Health Consultation

HOPEWELL PRECISION AREA GROUNDWATER CONTAMINATION SITE TOWN OF EAST FISHKILL, DUTCHESS COUNTY, NEW YORK

This health consultation was distributed for public comment from September 11th 2011 until October 14th 2011. DOH received multiple written comments; a summary of these comments and DOH's responses are included in Appendix E.

Hopewell Precision Area Groundwater Contamination Site Health Consultation Summary of Response to Public Comments

FIGURE 1. SITE LOCATION AND GROUNDWATER PLUME MAP

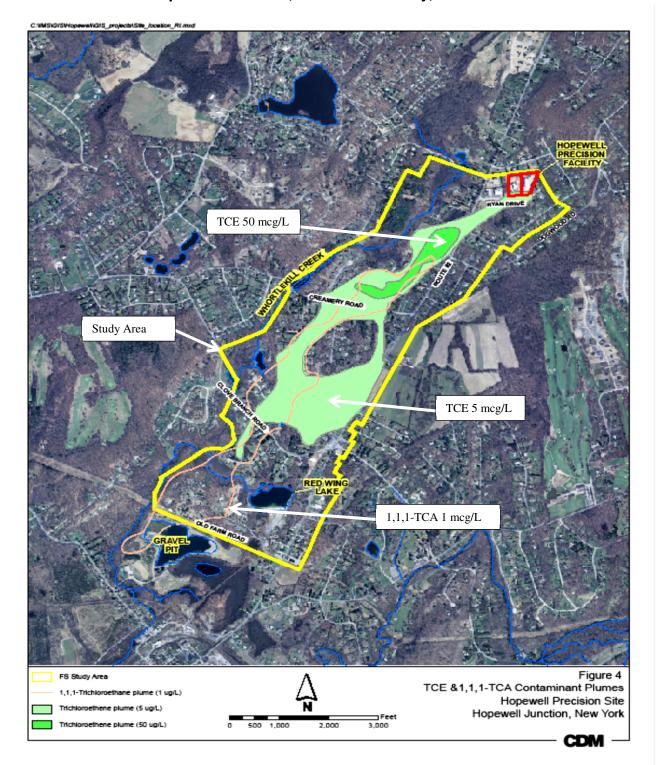
COMMENT 17: Figure 1 – Difficult to decipher. Need the plume boundaries defined more clearly. What does the white area in the middle represent (5 - 50 mcg/L)? What does the white perimeter line represent <5 mcg/L?

RESPONSE 17: The smaller inner plume represents 50 mcg/L of TCE, the larger plume represents 5 mcg/L of TCE. Captions have been added to aid in deciphering Figure 4. Additional figures are available in the 2008 Remedial Investigation Report available at the Town of East Fishkill Community Library document repository and on the EPA's website. http://www.epa.gov/region2/superfund/npl/hopewell/relateddocs.htm
